Reference: Oconee Unit 1
Docket No. 50-269

RESPONSE TO REQUEST FOR ADDITIONAL INFORMATION
CONCERNING THE OCONEE 1 INSERVICE INSPECTION PROGRAM

ATTACHMENT 1 - "Conformance with ASME Section XI, Inservice Examination"
Comments

JOCASSEE EARTHQUAKES

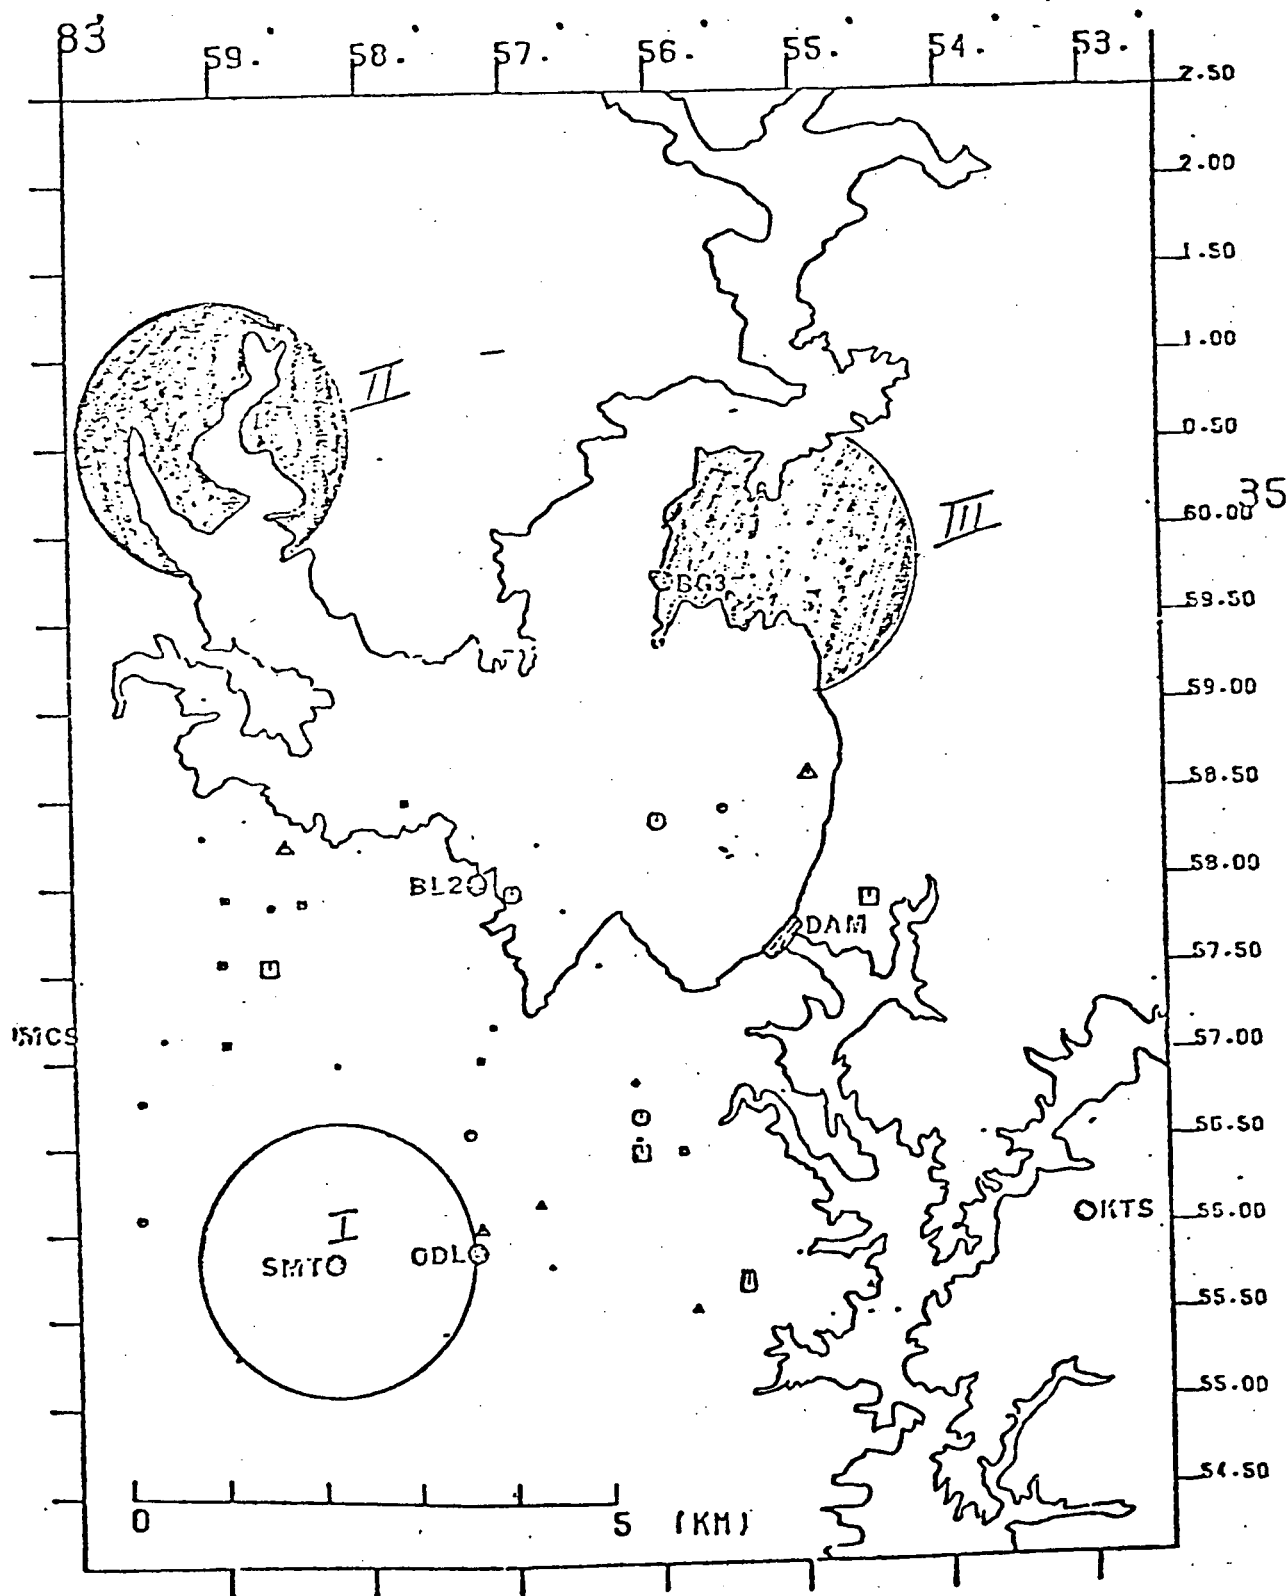
stations in addition to SMT should be installed as soon as possible. Suggested locations for these stations are shown in the attached figure. If possible, arrangements should be made with the USGS and USC to incorporate one or all of the Jocassee stations in the South Carolina network. This would allow recording of these stations on the delevelocorder at USC. If arrangements are made to include the stations in the network, it may be possible to use USGS radio frequencies for radio telemetry.
